Federal Aviation  
Administration

**ALAC CATERGAL AIRPLANE  
SPECIAL REVIEW TEAM REPORT  
MAY 2010**

**Figure 1: Comparison of FAA Estimated Loads with 'Zodiac CH 601 XL Stress Analysis and Tests'**

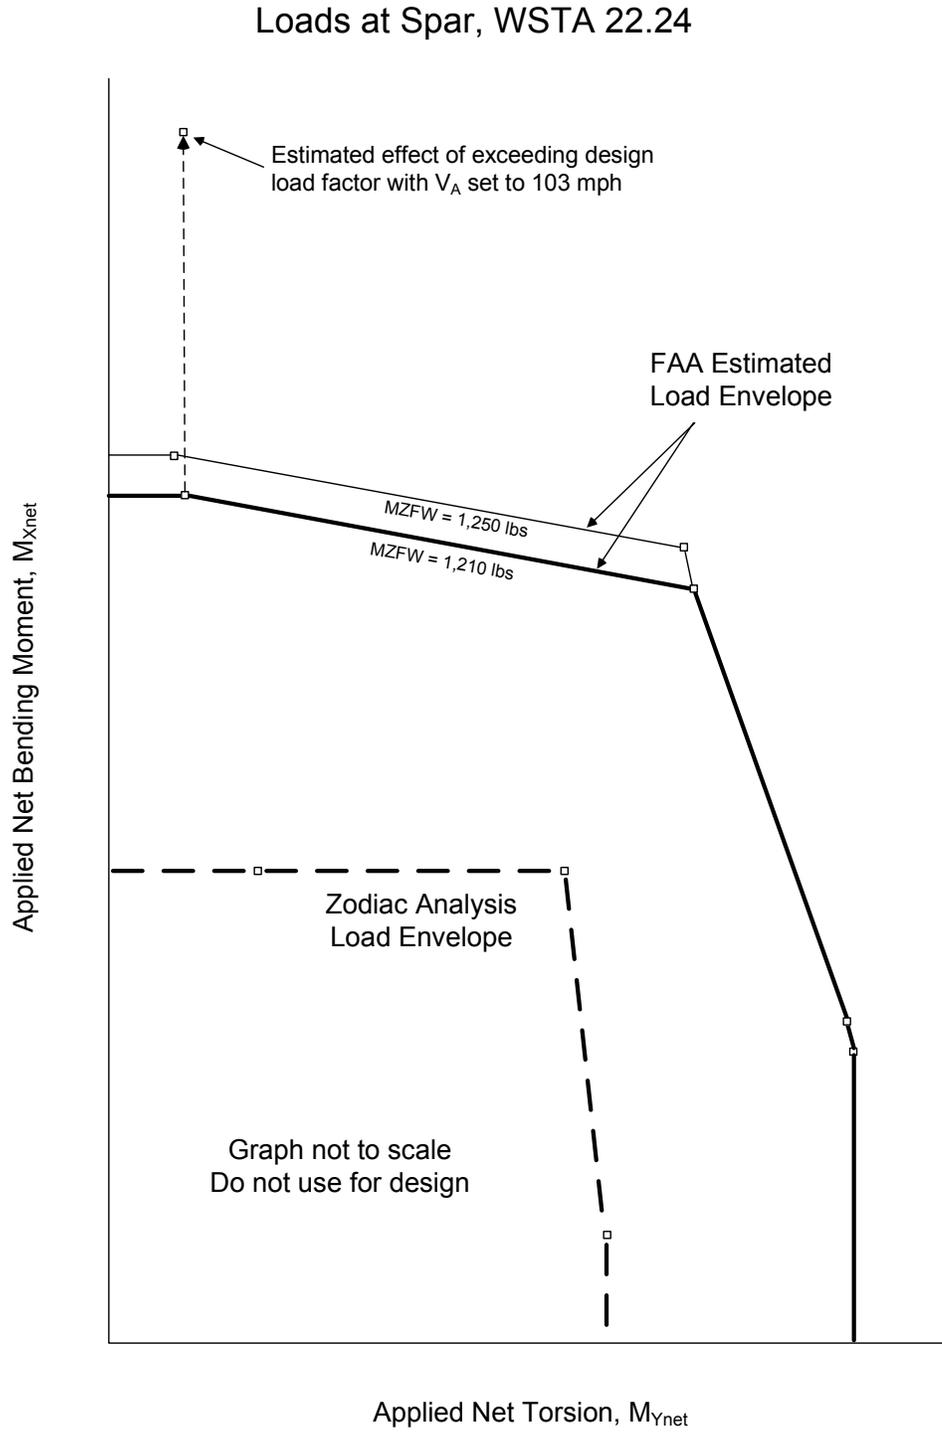
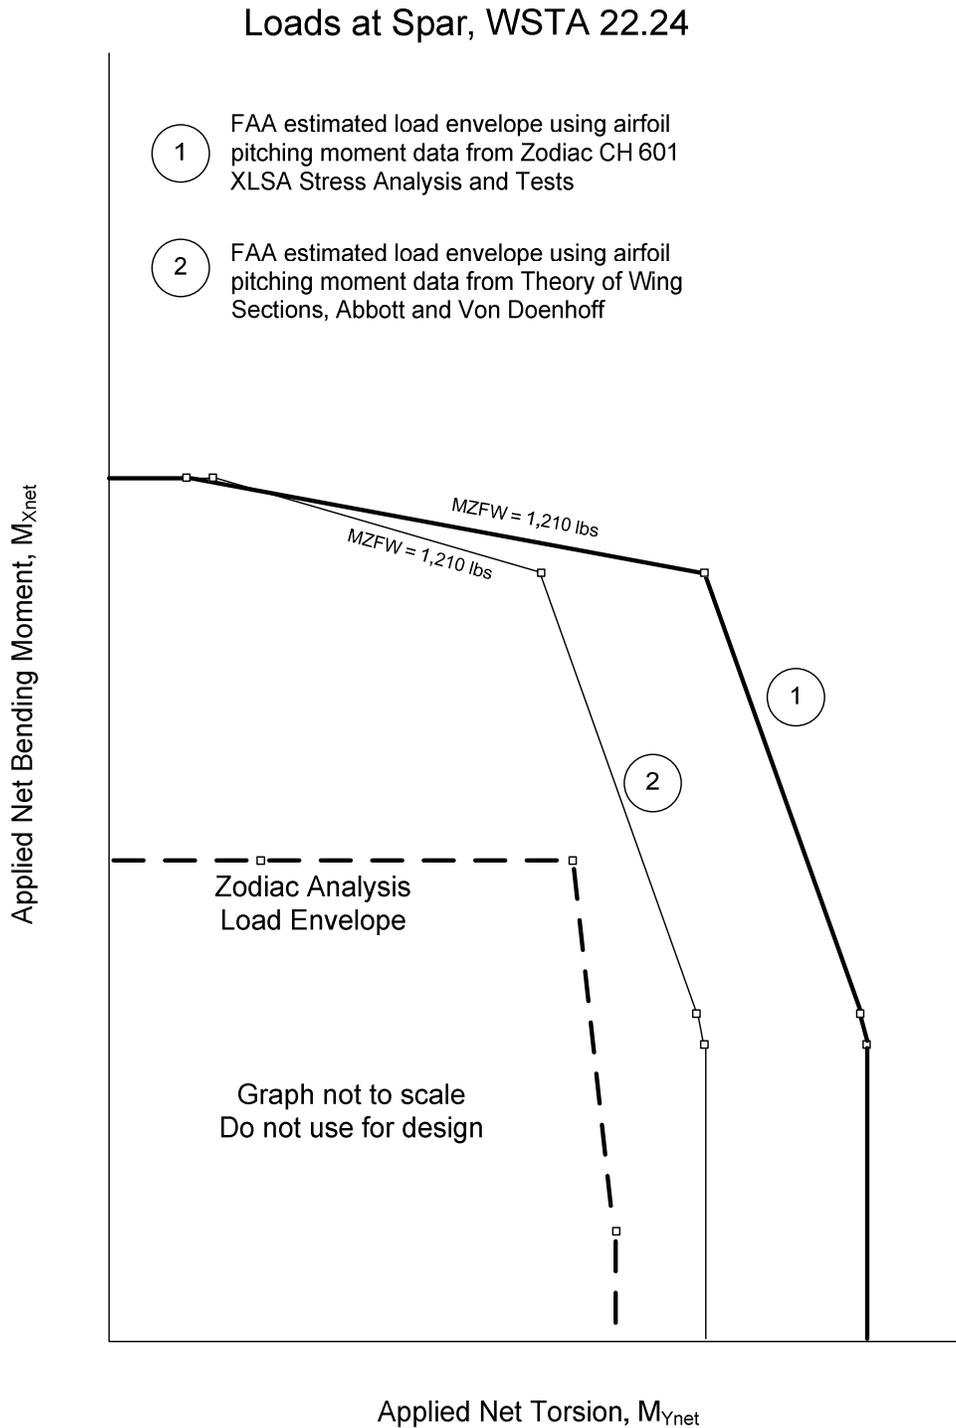
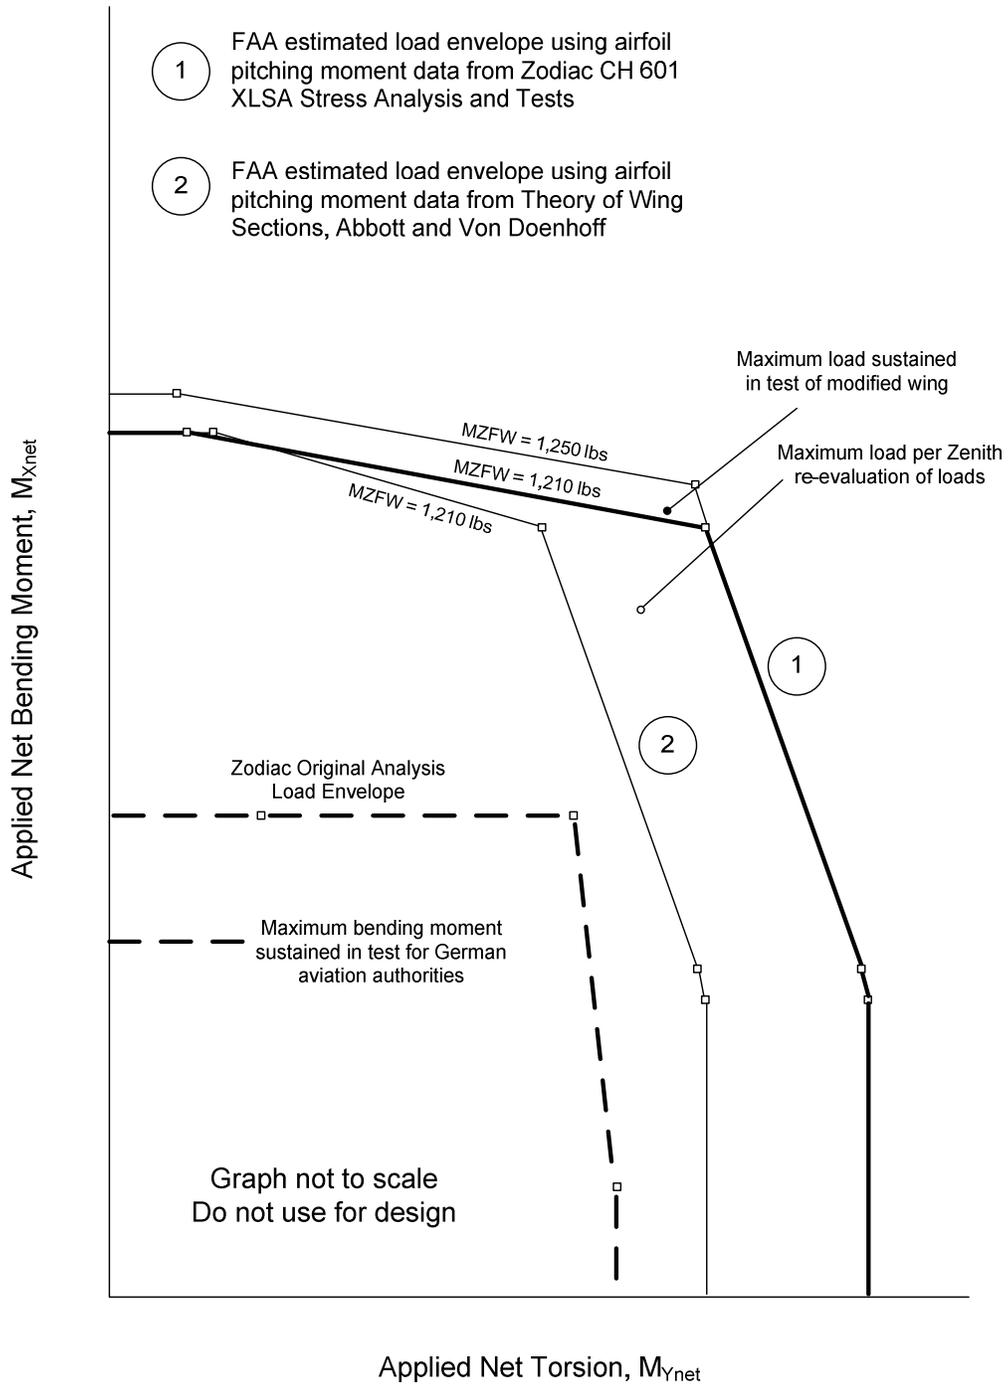
During our review, the FAA developed estimates of the wing bending and torsion loads to determine the relative importance of each of these issues. We estimated the wing loads assuming a minimum value for the MZFW of 1,210 lbs, based on an empty weight of 830 lbs and 380 lbs for the occupants. We also studied the effects of providing an increased MZFW of 1,250 lbs to account for differences in empty weight across the existing fleet, additional installed equipment (e.g. ballistic recovery systems), and for potential structural modifications to the design. Our estimated wing bending and torsion loads are significantly higher than those computed by the manufacturer, as shown in figure 1. (Note: We have removed the actual load values from figures 1 through 4 to protect the manufacturer's proprietary information and data.)

Figure 2: Effect of Pitching Moment Characteristics on Wing Design Loads

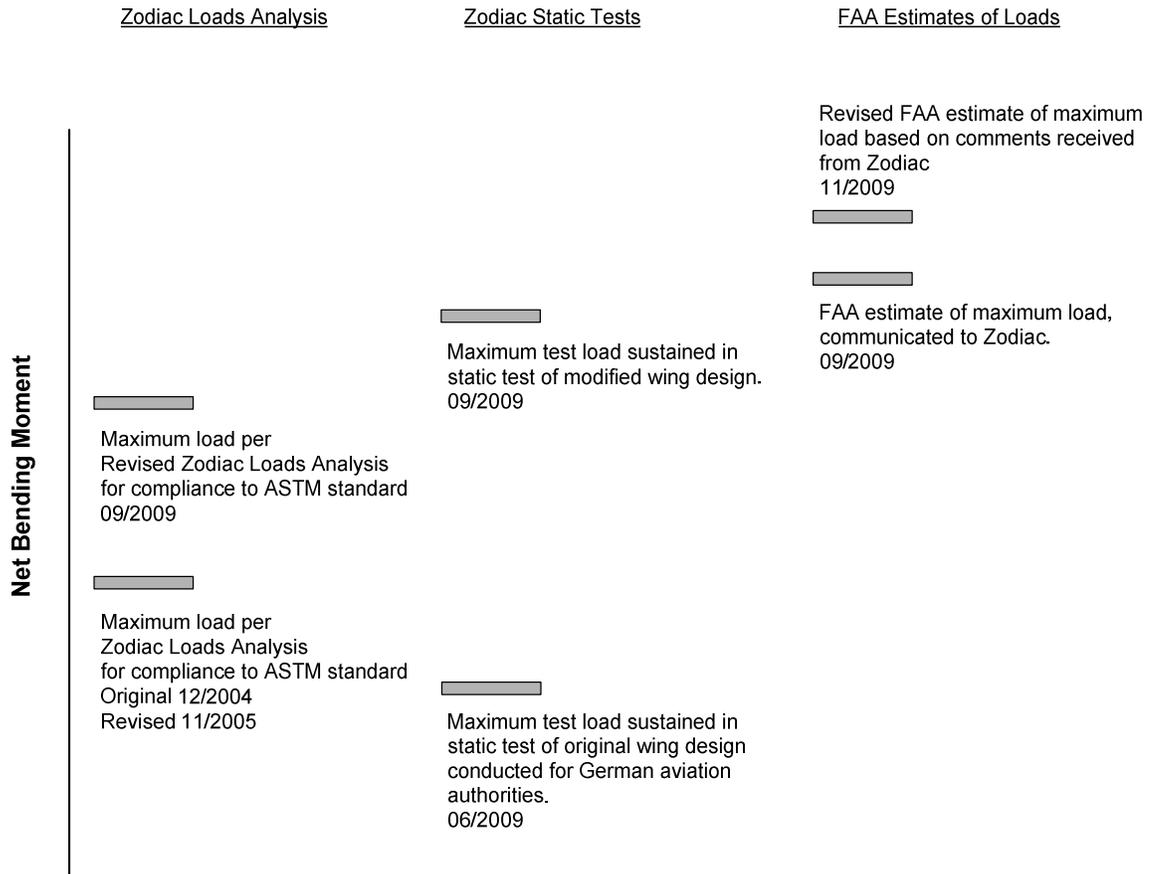
The FAA also studied the importance of the airfoil pitching moment data. As shown in figure 2, the accuracy of this data is critical in determining the torsion loads the manufacturer must use to design the wing. For comparison to the manufacturer's data during the completion of this study, we used wind tunnel test data from the widely used academic publication 'Theory of Wing Sections' by Abbott and Von Doenhoff for an airfoil that appeared to be similar to the one incorporated into the CH 601 XL wing.

Figure 5: CH 601 XL Stick Force per g Evaluation

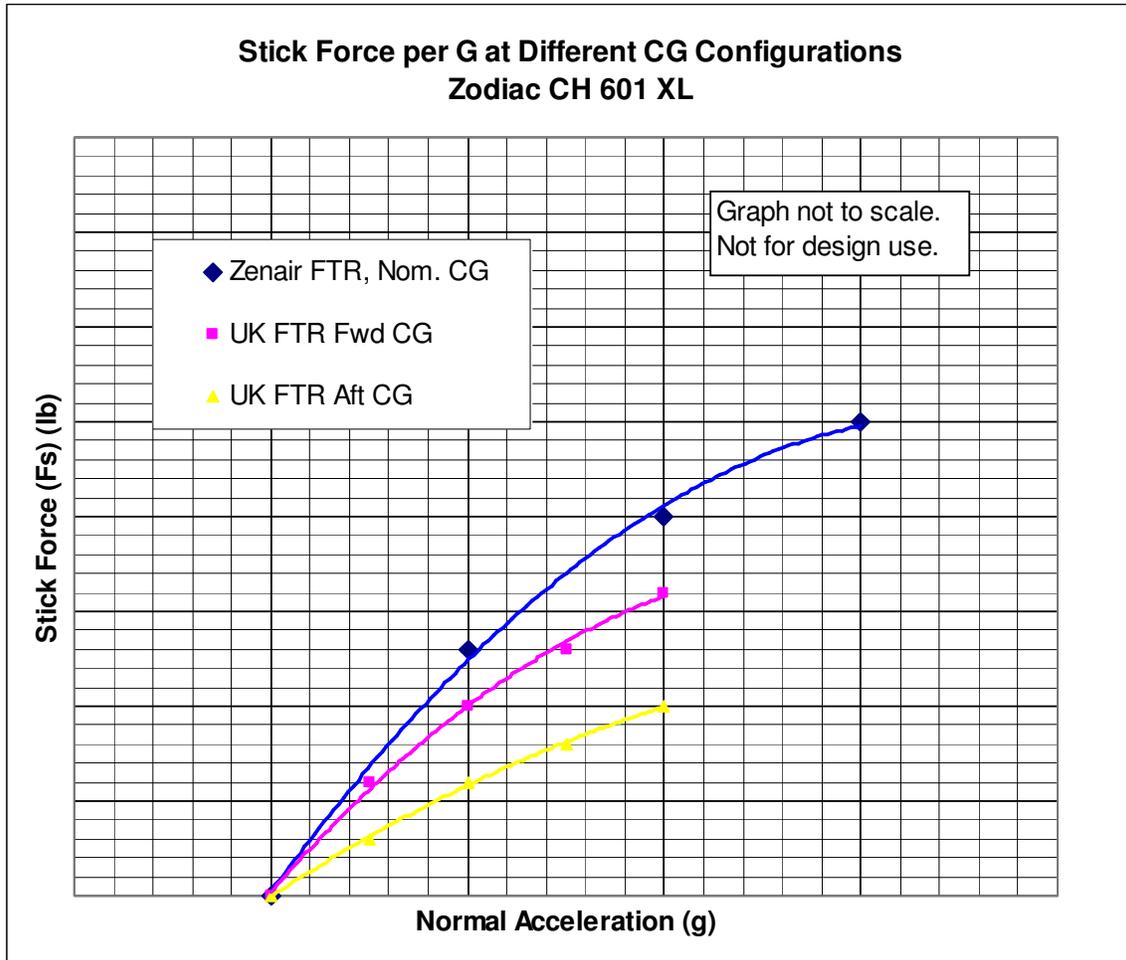
The UK LAA performed flight tests for a flutter mitigation program and provided the results to the FAA. Stick force per g evaluations were conducted at both forward and aft cg. Figure 5 shows the data they obtained appears to be compliant with the ASTM standards as well as with 14 CFR Part 23 § 23.155(c). (Note: We have removed the actual stick force and g load values from figure 5 to protect the manufacturer's proprietary information and data.)

Though not required to do so, it appears their tests followed the guidance provided by AC 23-8B. However, when applying this guidance to aft center of gravity data to match compliance with 14 CFR Part 23 § 23.155(a), Figure 5 shows the stick force at limit load appears to extrapolate to a value slightly less than the 15 pound minimum requirement at limit load. Though the CH 601 XL does not have to comply with 14 CFR Part 23, the data does indicate that stick force gradients may not be acceptable for aircraft that are intentionally or unintentionally flown outside the POH center of gravity limits. This is simply presented for regulatory comparison, as 14 CFR Part 23 § 23.155(a) is not currently reflected in the ASTM standards at any center of gravity configuration.

Figure 6: Standard Day Correction Effects on CH 601 XL Airspeed Calibration

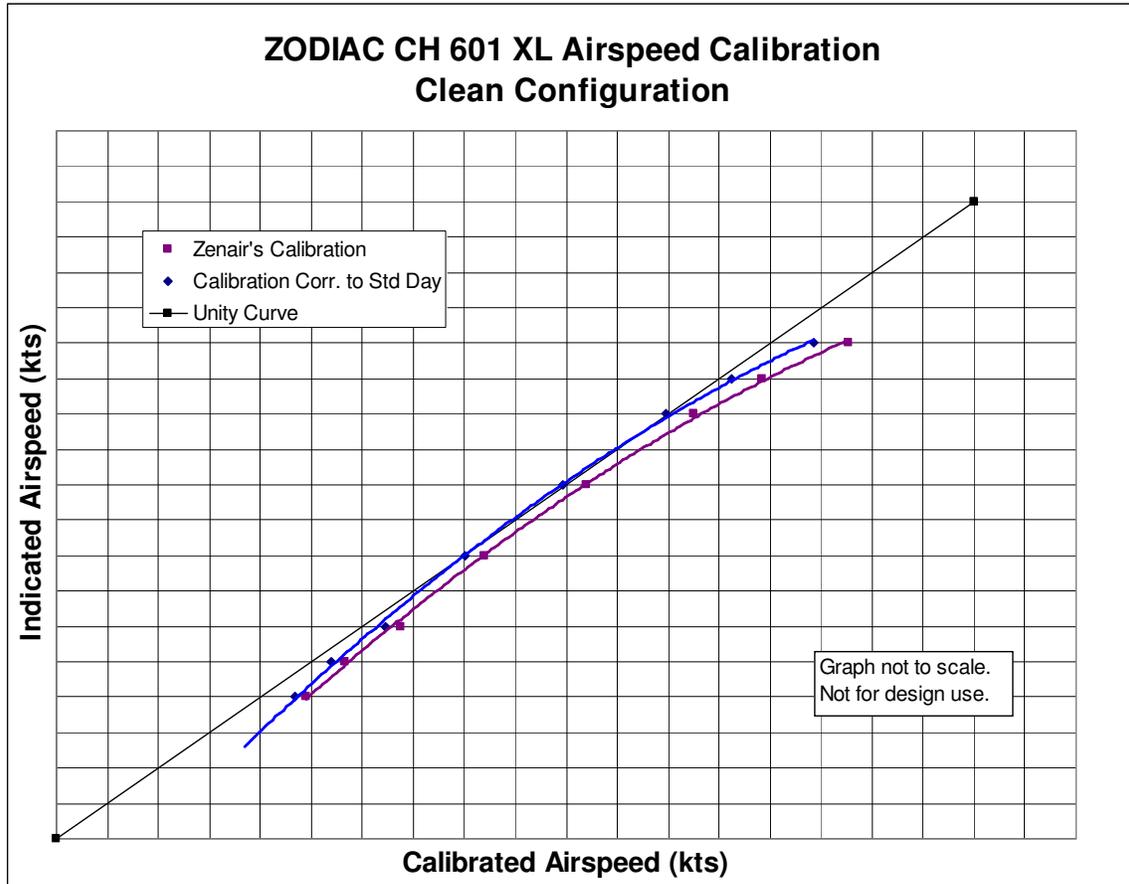
The manufacturer's flight test report was reviewed. It appears the airspeed calibration data presented was only calibrating indicated airspeed to true airspeed. Since this data was collected at a non-standard day temperature of 31°C, and at an altitude other than sea level, a density correction must be applied to the true airspeeds to accurately determine the calibrated airspeeds (compressibility effects are not applicable to light sport airplanes). Figure 6 shows the effect of applying a standard day correction to the airspeed calibration. (Note: We have removed the actual airspeed values from figures 6 through 8 to protect the manufacturer's proprietary information and data.)

Regarding stall speed, the manufacturer's flight test report determined the flaps up stall speed to be 35 knots indicated airspeed (KIAS) (40 mph) which was reported as 43 knots calibrated airspeed (KCAS) (50 mph). In reality, it was 43 knots true airspeed (KTAS) (49 mph), which after correcting to standard day conditions; the stall speed is calculated to be 41 KCAS (47 mph). The manufacturer's Airplane Flight Manual (AFM) reported a 43 knot (49 mph) flaps up stall speed indicating that standard day corrections were not applied to the flight test data.

Figure 7: Zodiac CH 601 XL Airspeed Calibration Comparison

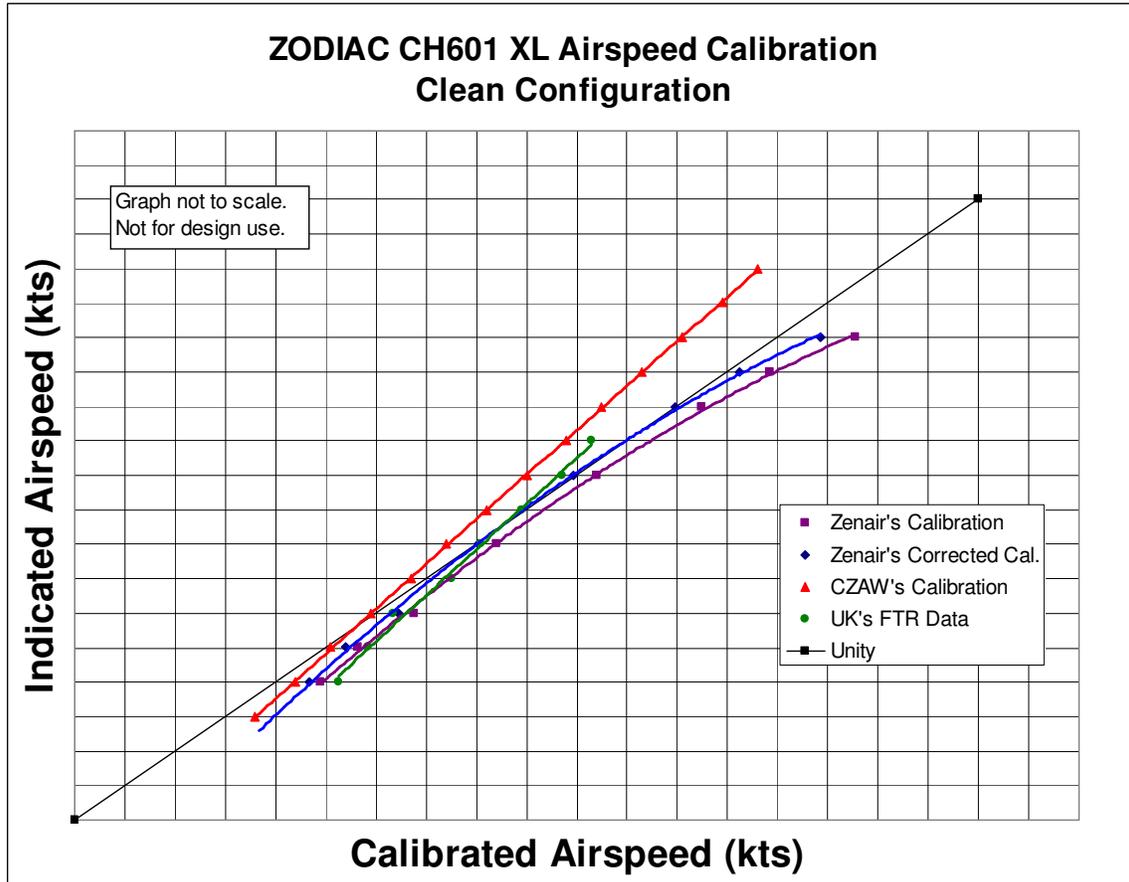
A comparison was made between CZAW and the manufacturer's airspeed calibrations. The calibrations were substantially different in both shape and magnitude. Without the flight test report, it is impossible to say which calibration is correct assuming that both designs are identical. Therefore, the potential to overspeed the aircraft exists. However, as part of the UK LAA flutter mitigation flight test program, an airspeed calibration was conducted and the results were overlaid with those from the manufacturer and CZAW, as seen in Figure 7. (Note: We have removed the actual airspeed values from figures 6 through 8 to protect the manufacturer's proprietary information and data.)

**Figure 8: Zodiac Airspeed Calibration Evaluation per 14 CFR Part 23 § 23.1323(b)**

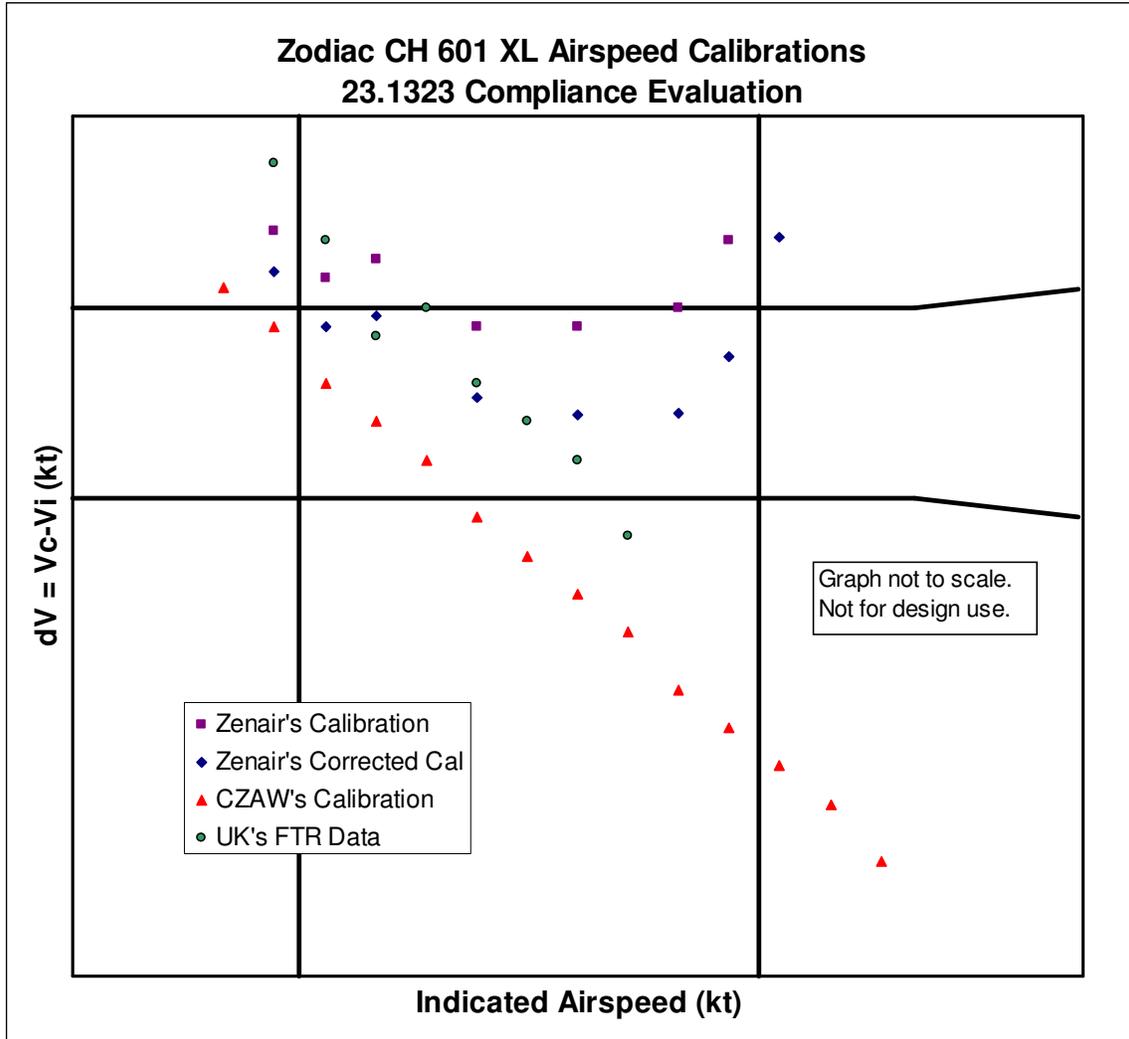
The UK LAA's flight test results are similar in magnitude to the manufacturer's data, but trend with CZAW's data making the comparison inconclusive. Using a different approach to determine the validity of the calibration data, a 14 CFR Part 23 § 23.1323(b) analysis was performed on these data sets and shown graphically in Figure 8. It should be

To evaluate the airspeed error per 14 CFR Part 23 § 23.1323(b), the error  $dV$ , must be less than  $\pm 5$  knots or 3% bounded by a lower airspeed of  $1.3V_{S1}$  to a maximum airspeed of  $V_{NE}$ . Using the manufacturer's values, this means that to meet 14 CFR Part 23 § 23.1323(b), all the applicable data needs to fall in the enclosed  $\pm 5$  knot rectangle.
